Materials Schedule – 9 Nestles

Rev P5

9 Nestles Avenue, Hayes UB3 4SA

Project No.	1908
File Reference	1.7

Balconies

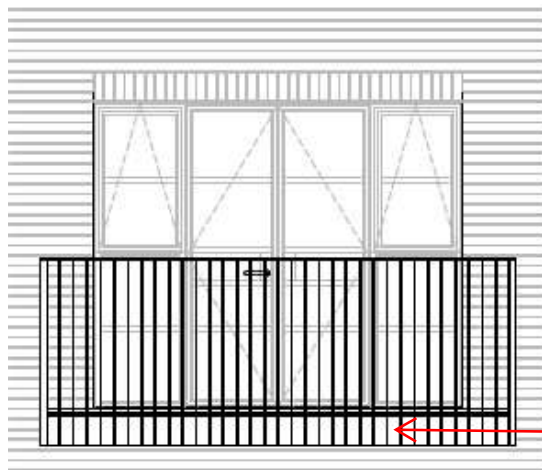
Please note the majority of the materials identified herein were approved via application ref 51175/APP/2023/1786. This application seeks only to vary the base detail proposed to the balconies. This variation is proposed to overcome problems with detail design and fixing to the reinforced concrete structure. The proposed alternative is visually very similar.

Previous approval. Balcony detail
approved under application
51175/APP/2023/1786
to be revised.

New proposal. Revised base
detail to balcony- fascia plate
with continuous railings
detail proposed for approval

New proposal. Revised base
detail to balcony- fascia plate
with continuous railings
detail proposed for approval
